Re: NHDES Wetland Application 2020-02239 (Casella), WQC & Indirect Impacts

In reviewing the “19045_Wetland Impact Plans” prepared by Horizons Engineering and dated August 2020, I note the following:

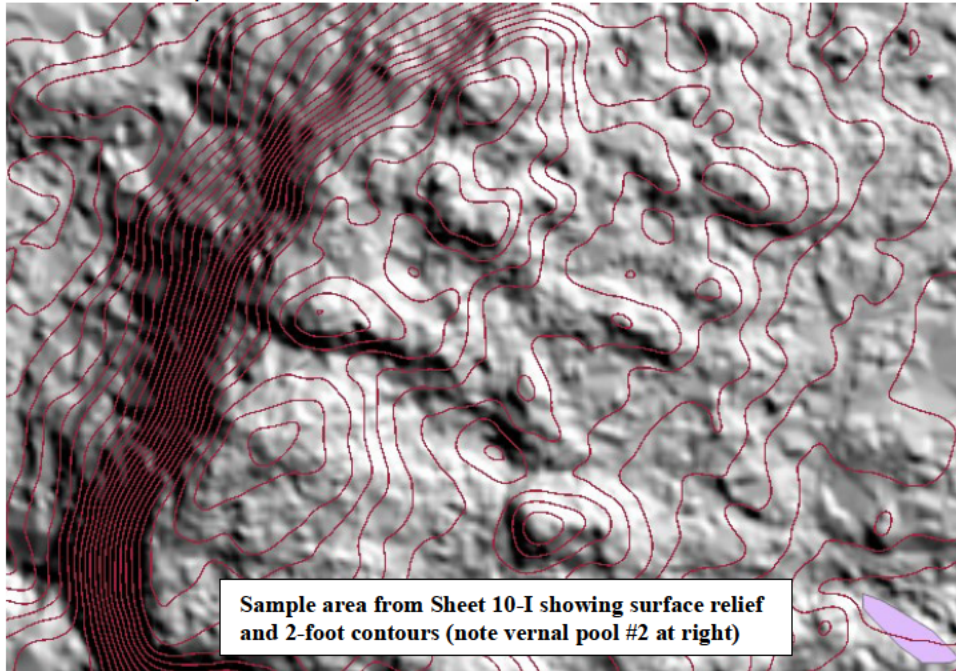
1. On Page 3, the Response indicates that the landfill base liner “is to be set 6 feet above the seasonal high groundwater table,” yet there are no indications where the seasonal high groundwater table is throughout the site, nor are there any assurances that any

blasting that is required will alter or destroy the existing pattern of run-off and/or infiltration. I include the following sample site map showing Lidar-based relief and 2-foot contours from Sheet 10-I to illustrate how challenging it will be to achieve landfill liner consistency that lies six feet above a SHWT:

- Careful hydrologic studies must be completed to prove beyond a shadow of a doubt that the stormwater detention basins will not dewater existing wetlands or cause an interruption in the natural hydrology of these systems; these studies must also be able to prove that any bedrock blasting will not irreparably harm or alter the natural flowpaths of surface and groundwater above the wetland systems
